Project Name: **Westerlea View Lofts: 54 unit residential development plus 1 commercial space**
Project ID: #2016-184 (Subdivision & Site Plan) and
#2016-185 (Conditional Use Inclusionary Zoning)
Address: 75 Chestnut Street CBL: 26/E/10
Applicant: A&M Partners Inc
Planner: Jean Fraser

Subject: B7 Design Review – 75 Chestnut Street

Subject: B7 Design Review Site Plan Amendment – 75 Chestnut Street

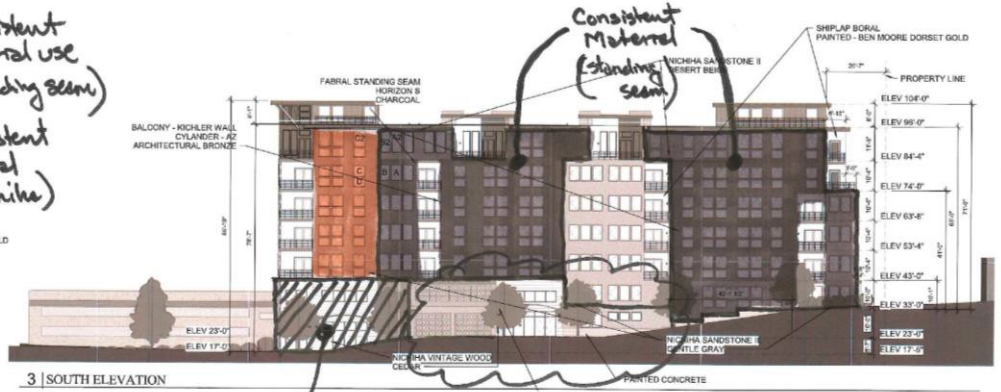
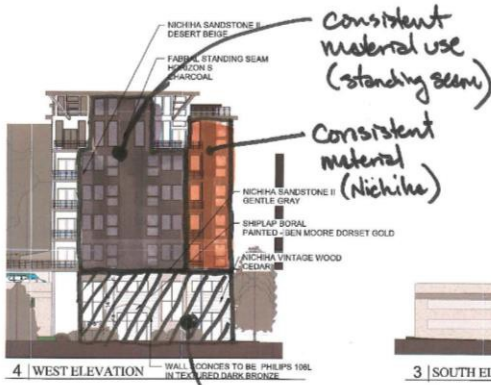
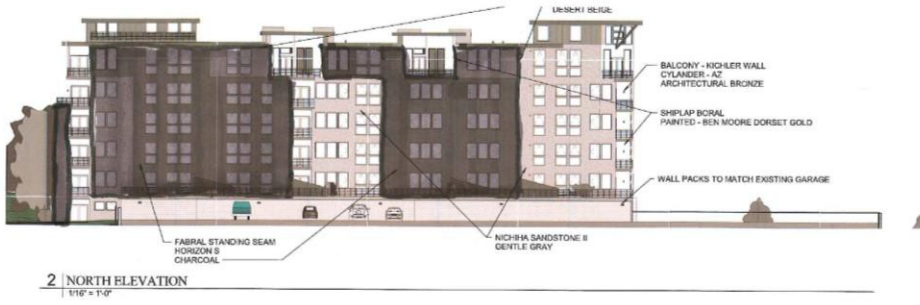
- The base of the building should be more consistently defined, especially on the Chestnut Street side. At this point, that can best be achieved through articulation, material placement and detailing. The corner, double-height live-work unit could also be more substantially differentiated from the other masses of the building.

- The level of detail and articulation on the Chestnut Street elevation is not sufficient, especially at the street level. Material changes are mostly arbitrary and other than at the entrance, do not correspond to uses or plane changes. Revisions to meet this standard could come in form of enclosure; articulation and detail (reveals, dimensional trim, material transitions, detail); placement of material that corresponds with uses

Consistent material use differentiating this corner unit

Ped level articulation + match floor plans
